UNITED STATES PATENT AND TRADEMARK OFFICE

APPLICATION NO.	FILING DATE	FIRST NAMED INVENTOR	ATTORNEY DOCKET NO.	CONFIRMATION NO.
10/802,177	03/17/2004	Timothy W. Mehnert	36185	3849
116	7590	03/24/2005	EXAMINER	
PEARNE & GORDON LLP 1801 EAST 9TH STREET SUITE 1200 CLEVELAND, OH 44114-3108			VASUDEVA, AJAY	
			ART UNIT	PAPER NUMBER
			3617

Office Action Summary

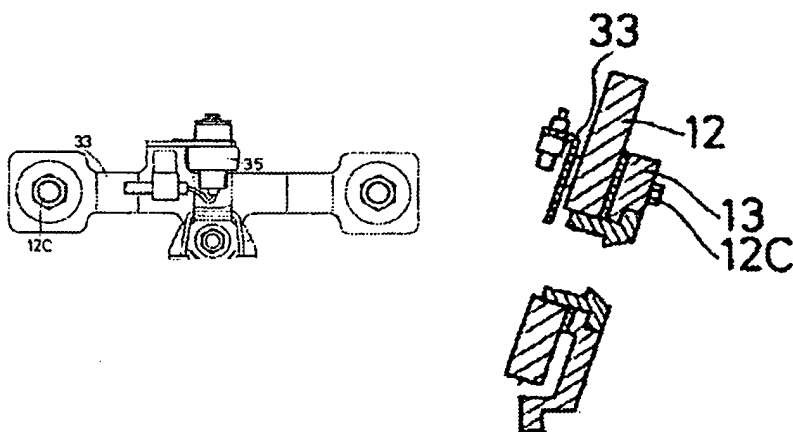
Re claims 1 and 8, JP ('295) shows an apparatus comprising a cam [40] coupled to a steering linkage bar [18] of a watercraft, and a switch [35] coupled to a fixed portion of the watercraft (figures 1, 2 and 3).

It is well known in the art that the lower cowl structure of an outboard motor functions as a rudder, and the position of the rudder corresponds to the position of the outboard motor. In the present case, the cam activates the switch when the outboard motor – and consequently the rudder – is in a centered position. Therefore, the switch is considered activated “when the rudder of the watercraft is in a centered position”.

The position of the steering linkage bar provides a visual indication of the rudder position, and is therefore considered to be a “rudder position indicator” (preamble of claim 1) or the “means for indicating when the rudder is centered” (claim 8, line 5)

Regarding the limitation “means for contacting the cam” (claim 8, line 3), the switch that comes in contact with the cam when the rudder is in a centered position is considered equivalent to the means for contacting the cam.

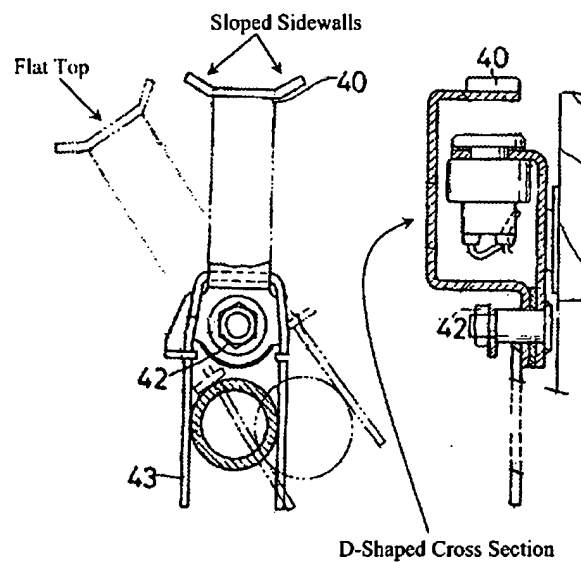
Re claim 6, the apparatus comprises a plurality of brackets [33,13], wherein a second bracket [13] and nut-bolt fasteners [12C] are employed to secure the first bracket [33] to the fixed portion of the watercraft. The switch – which itself is mounted on the first bracket – is therefore considered to be secured to the fixed portion of the watercraft by the first and second brackets. *(see simplified illustration below, as modified from figures 1 and 2).*

Further, the limitation "brackets are adjustable to adjust a sensitivity of the switch", as best understood from the specification, has been broadly interpreted to mean an "adjustment in

the position" of the switch. In this regard, a loosening of the bolts would allow both brackets to shift relative to the fixed portion of the watercraft, and would correspondingly change the position of the switch. Therefore, the brackets are considered as being adjustable by loosening of the nut-bolt fasteners, which will adjust the "sensitivity" of the switch, as broadly interpreted above.

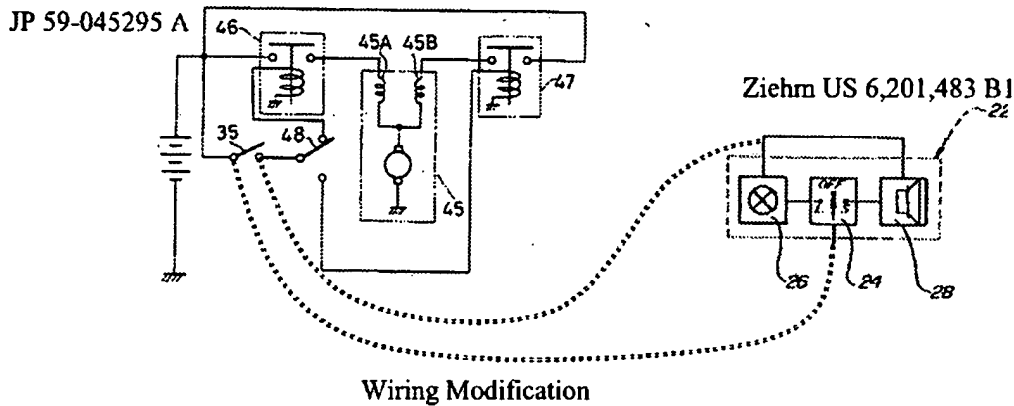
JP ('295) shows a switch that is activated when the rudder of a watercraft is in a centered position, and discloses all limitations of claims 1 and 8.

However, JP ('295) is silent on:

- (i) the switch being electrically connected to an indicator light, or
- (ii) the indicator light being located on a dash of the watercraft.

Ziehm shows boat having an indicator system to signal a centered position of a steering. The indicator system has an indicator light [26] that is activated by an electrically-connected switch [18] when the steering is in a centered position (col. 1, lines 36-48). The indicator light is mounted on a panel adjacent the boat steering wheel or helm station (col. 2, lines 63-64). The "panel" is considered to be an equivalent of a "dash".

It would have been obvious for one skilled in the art at the time of the invention to include an indicator light with the center-detecting switch of JP ('295), as taught by Ziehm. Having such indicator light would have provided a sure mechanism to alert an operator when it was safe to initiate a tilting operation of the outboard motor, regardless of the ambient light conditions. Such indicator light would have also provided a guidance mechanism for steering the watercraft in a straight direction, which would have further improved the operational safety (*see below for a simplified illustration of one possible modification of JP '295, as modified by Ziehm*).
